Planning Commission - Regular Meeting City and Borough of Juneau Ben Haight, Chair

April 26, 2016
Assembly Chambers
7:00 PM

PROPOSAL: A State Project Review for extension and replacement of the sidewalk on the uphill side of Douglas Highway from Lawson Creek Road to Gastineau Elementary School.

File No:	CSP2016 0005	Applicant:	State of Alaska
To:	Adjacent Property Owners	Project Area:	Douglas Highway (3rd Street) from Lawson Creek Road to I Street
Hearing Date:	April 26, 2016	Owner:	State of Alaska
Hearing Time:	7:00 PM	Project Length:	Approximately 2,000 feet
Place:	Assembly Chambers Municipal Building 155 South Seward Street Juneau, Alaska 99801	Zoned:	D-18
		Site Address:	Douglas Highway (3rd Street)

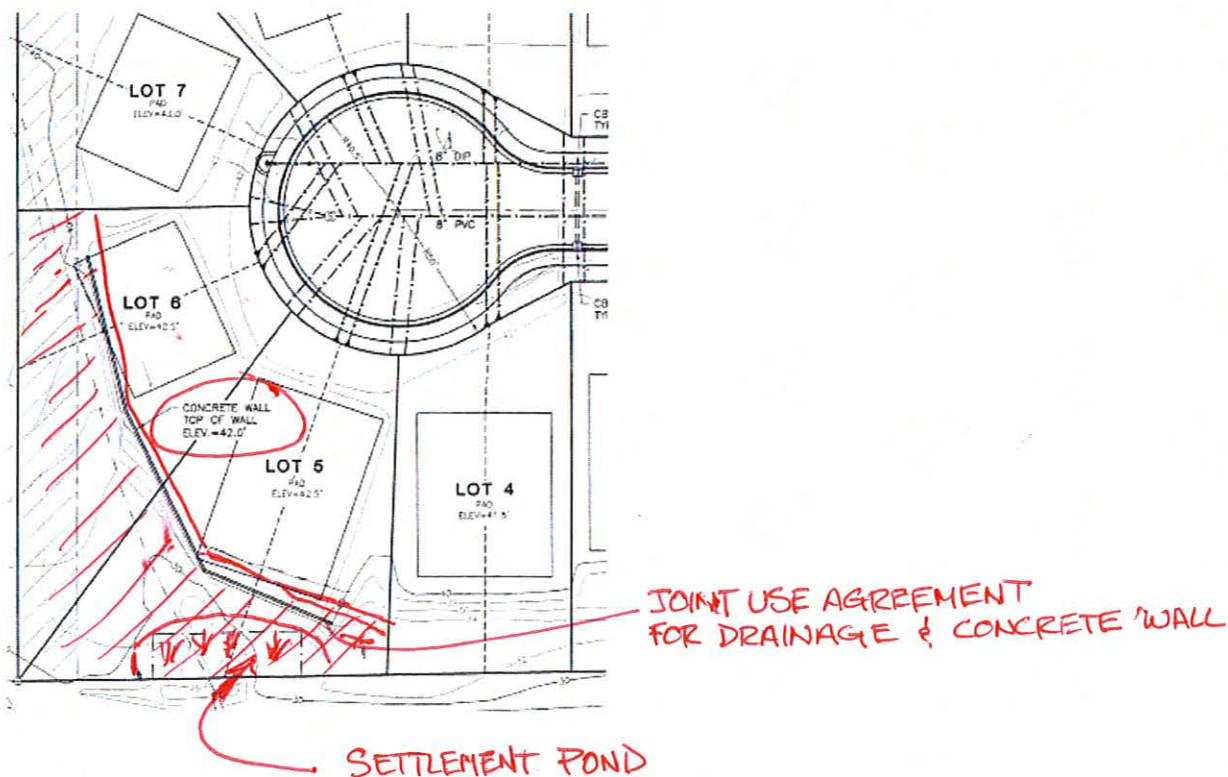
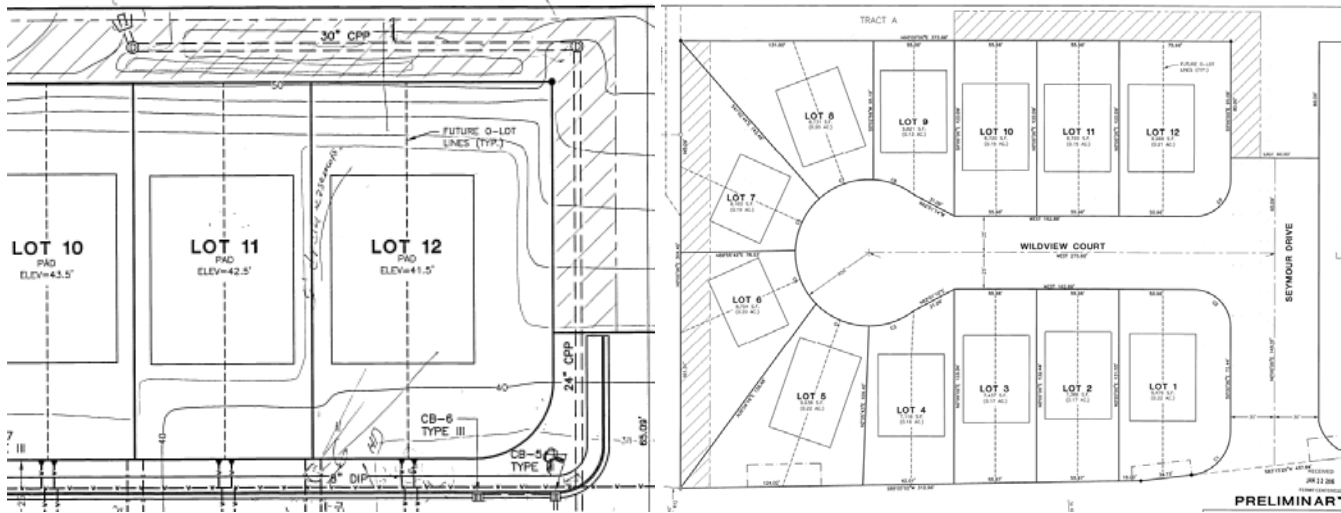
The plat delineates an unknown width easement for the existing drainway that runs along the west border of the property. The grading plan shows a common drainage and a joint retaining wall on Lots 5, 6 & 7. All of the drainage area and concrete wall within Lots 5, 6 & 7 requires an easement along with a joint use hold harmless agreement for maintenance and reconstruction of the wall. In addition the drainage below the wall will have to be reconstructed (Title 19.12) and a settlement basin installed at the cross culvert intake. All the drainage and concrete wall must be within a private drainage easement and maintained by the property owners.

Also the plat shows an easement (Tract A below) intended for a rerouted storm drainage through a 30"CPP into a 24" CPP. The plan includes an overflow berm and channel in case of catastrophic failure. The CBJ will not accept that drainage and it shall the responsibility of the property owners to provide maintenance and liability if there is a drainage failure.
